RESPONSE TO MOTOROLA'S
NOVEMBER 27, 1995
LETTER TO
MR. THOMAS S. TYCX
FCC INTERNATIONAL BUREAU

**COMMENTS TO MOTOROLA'S
PROPOSED RULES
FOR 28 GHZ
DATED NOVEMBER 27, 1995**

(b) Hub-to-Subscriber transmission

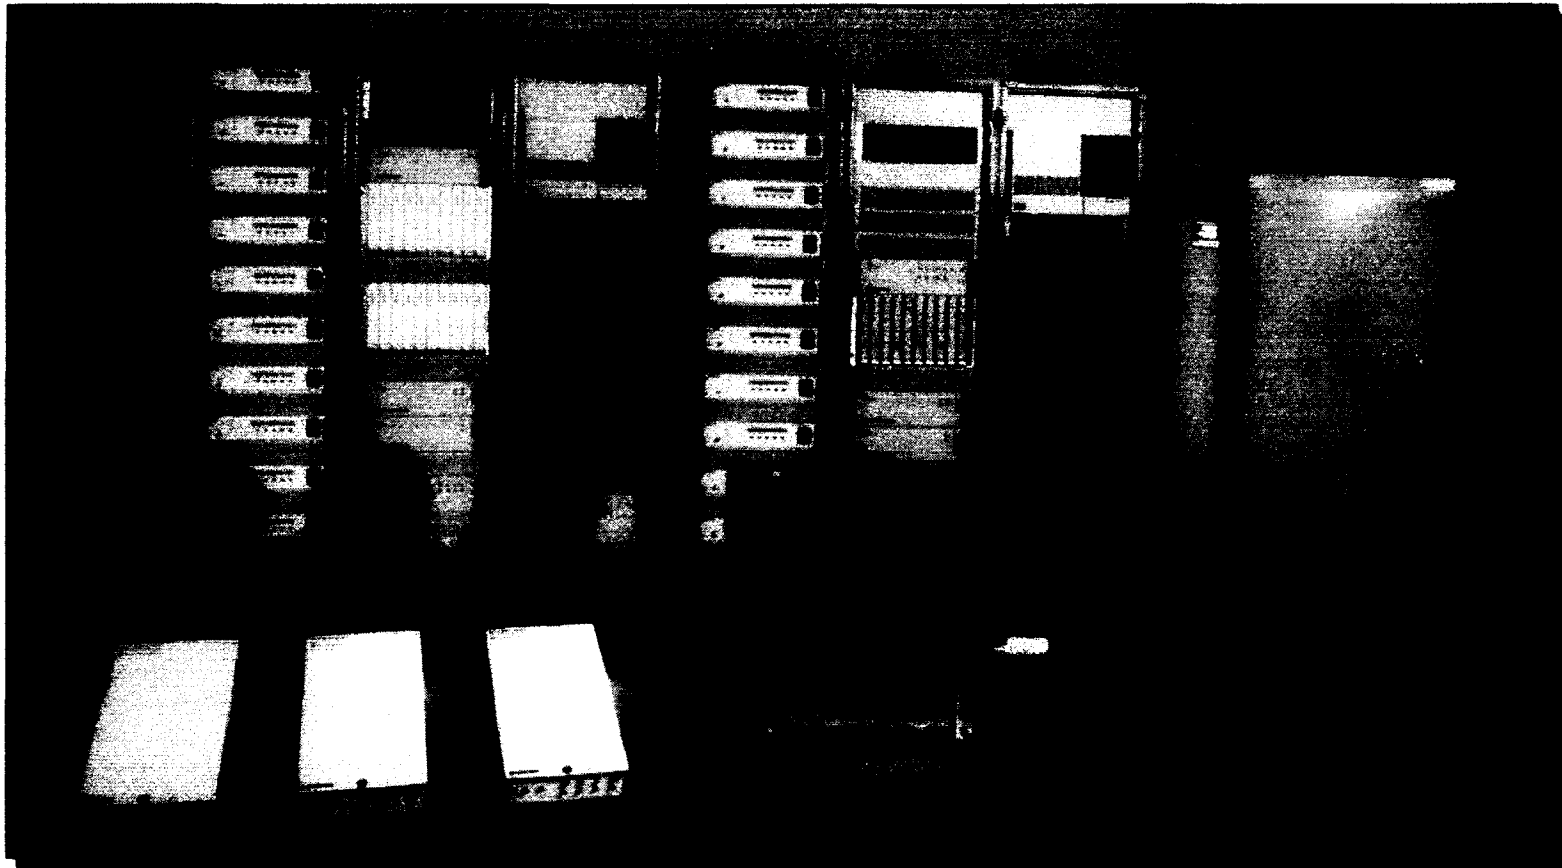
Hub to subscriber transmission on these frequencies should not be excluded unless they are used for subscriber transmission within a particular hub cell.
